UNITED STATES PATENT AND TRADEMARK OFFICE

APPLICATION NO.	FILING DATE	FIRST NAMED INVENTOR	ATTORNEY DOCKET NO.	CONFIRMATION NO.
10/797,463	03/10/2004	Kyoung-Hwan Yeo	5649-1238	4432
20792 7590 11/15/2007 MYERS BIGEL SIBLEY & SAJOVEC PO BOX 37428			EXAMINER	
			STARK, JARRETT J	
RALEIGH, NC 27627			ART UNIT	PAPER NUMBER
			2823	
			MAIL DATE	DELIVERY MODE
		•	11/15/2007	PAPER

Application No.	Applicant(s)				
	10/797,463	YEO ET AL.				
Office Action Summary	Examiner	Art Unit				
	Jarrett J. Stark	2823				
The MAILING DATE of this communication appears on the cover sheet with the correspondence address Period for Reply						
A SHORTENED STATUTORY PERIOD FOR REPLY IS SET TO EXPIRE 3 MONTH(S) OR THIRTY (30) DAYS,						
WHICHEVER IS LONGER, FROM THE MAILING DA - Extensions of time may be available under the provisions of 37 CFR 1.13 after SIX (6) MONTHS from the mailing date of this communication. - If NO period for reply is specified above, the maximum statutory period w - Failure to reply within the set or extended period for reply will, by statute, Any reply received by the Office later than three months after the mailing earned patent term adjustment. See 37 CFR 1.704(b).	ATE OF THI

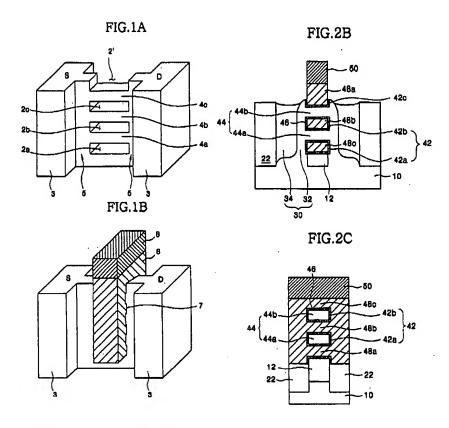
Claims 12-30 rejected under 35 U.S.C. 102(e) as being anticipated by <u>Kim et al.</u> (US 7,002,207).

Regarding claims 12 - 30, <u>Kim et al. 3</u> discloses a method of forming a unit cell of a metal oxide semiconductor (MOS) transistor, comprising:

forming a MOS transistor on an integrated circuit substrate including an isolation layer and an active region higher than the isolation layer, the MOS transistor having a source region and a drain region on the isolation layer, and a plurality of gates on the active region, the plurality of gates being stacked between the source region ant the drain region (Kim, Figurs 1A, 1B, 2B and 2C);

forming a horizontal channel between the source and drain regions, the horizontal channel including at least two horizontal channel regions formed in spaced apart patterns, wherein the source and drain regions are vertically formed to cover the sides of the active region in other patterns adjacent to sides of the spaced apart patterns (Kim, Figurs 1A and 1B).

FIG. 30

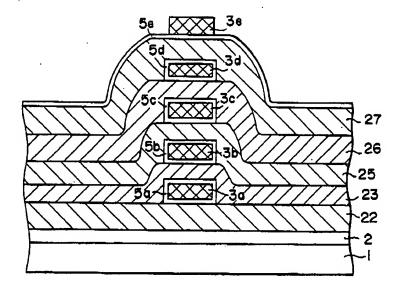
Regarding claims 12 and 30, Maegawa discloses a method of forming a unit

cell of a metal oxide semiconductor (MOS) transistor, comprising: forming a MOS transistor on an integrated circuit substrate including an isolation layer (fig. 30 layer 2) and an active region higher than the isolation layer (Fig. 30, layers 3a, 3b, 3c, 3d, 3e,...), the MOS transistor having a source region and a drain region (not shown due the cross-sectional view of figure 30, however source and drains are inherently required to be adjacent either side of each channel. A channel can not function without a source and drain) on the isolation layer, and a plurality of gates on the active region, the plurality of gates being stacked (Fig. 30, layers 22, 23, 25, 26, 27,...) between the source region ant the drain region (not shown due the cross-sectional view of figure 30, however source and drains are inherently required to be adjacent either side of each channel. A channel can not function without a source and drain);

forming a horizontal channel between the source and drain regions, the horizontal channel including at least two horizontal channel regions formed in spaced apart patterns (Fig. 30), wherein the source and drain regions are vertically formed to cover the sides of the active region in other patterns adjacent to sides of the spaced apart patterns (not shown due the cross-sectional view of figure 30, however source and drains are inherently required to be adjacent either side of each channel. A channel can not function without a source and drain)

Regarding claim 17, Maegawa discloses the method of claim 16, further comprising: forming a gate pattern (Fig 30-[26]) on the horizontal channel (Fig 30-[3c]) and between the at least two spaced apart horizontal channel regions (Fig 30-[3c and 3d]); and forming a gate insulation layer (Fig 30-[5c and 5d]) between the gate pattern and the at least two spaced apart horizontal channel regions.

FIG. 15

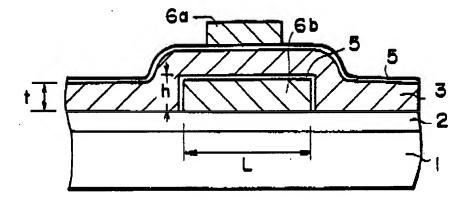
Regarding claim 16, Maegawa discloses the method of claim 12, wherein forming the source and drain regions comprises forming vertical source and drain regions, the vertical source region being on a first side of the horizontal channel region and the vertical drain region being on a second side of the horizontal channel region and spaced apart from the vertical source region (Fig 15 & Col. 6 lines 53-57).

forming a first insulation pattern (Fig 15. – insulation layers [2] and/or [5]) between the source and drain electrodes and the integrated circuit substrate and between the gate pattern and the integrated circuit substrate.

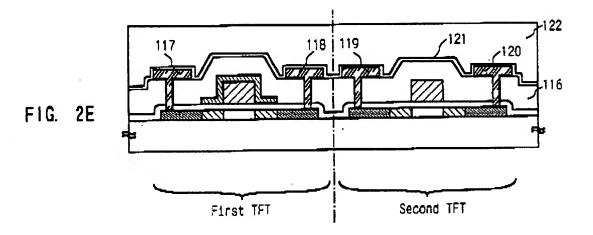
Regarding claim 20, Maegawa in view of Nakajima discloses the method of claim 19, further comprising: forming a second insulation pattern (Fig. 15 – [5]) on the horizontal channel and the vertical source and drain regions (Fig. 15 – [3] – source and

drain regions left and right of gate 6a), wherein the second insulation pattern defines a gate opening on the horizontal channel (Fig. 15 – circled by Examiner for clarity), wherein the gate pattern is provided in the gate opening and

Maegawa does not explicitly disclose wherein the source and drain electrodes extend through the second insulation pattern and are connected to the vertical source drain regions. It is however notoriously well known extend the source and drain electrodes through the insulation pattern to make electrical contact with the source and drain electrodes. An example of this is shown by Nakajima in Figure 2E below. The figure shows a commonly used method of connecting source and drain electrodes to the source and drain trough an insulating layer.

It would have been within the scope of one of ordinary skill in the art at the time of the invention to combine the teachings of Maegawa and Nakajima to enable the source/drain electrode formation step of Maegawa to be performed according to the teachings of Nakajima because one of ordinary skill in art at the time of the invention would have been motivated to look to alternative suitable methods of performing the disclosed source/drain electrode formation step of Maegawa and art recognized suitability for an intended purpose has been recognized to be motivation to combine.

Regarding claim 21, Maegawa in view of Nakajima discloses the method of claim 20, further comprising: forming a third insulation pattern on the second insulation pattern and the gate pattern, wherein the source and drain electrodes extended through the third insulation pattern (Nakajima, layer [116]) and the second insulation pattern and are connected to the vertical source and drain regions.

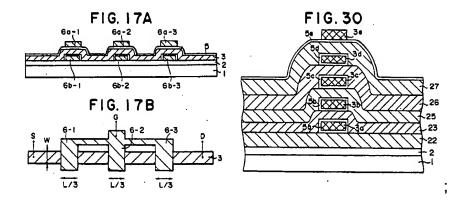
Regarding claim 22, <u>Maegawa</u> in view of <u>Nakajima</u> discloses the method of claim 21, wherein an upper surface of the first insulation pattern is higher relative to a lower surface of the gate pattern. (<u>Maegawa</u>, Fig. 15 first insulating layer [5] is above lower gate pattern [6b])

Regarding claim 23, <u>Maegawa</u> in view of <u>Nakajima</u> discloses a method of fabricating a transistor comprising:

forming a trench region on an integrated circuit substrate to define an active region (Maegawa, Fig. 1A);

forming a stacked structure including at least one set of first epitaxial patterns and second epitaxial patterns on the active region (Maegawa, Fig. 30);

forming a first insulation pattern on a floor of the trench (<u>Maegawa</u>, Fig. 1B);; growing a third epitaxial layer on sidewalls of at least one set of first and second epitaxial patterns(<u>Maegawa</u>, Fig. 1A);

forming a second insulation pattern on a surface of the integrated circuit substrate, the second insulation pattern defining a gate opening that exposes at least a portion of the third epitaxial layer (Figs 17A-B & 30);
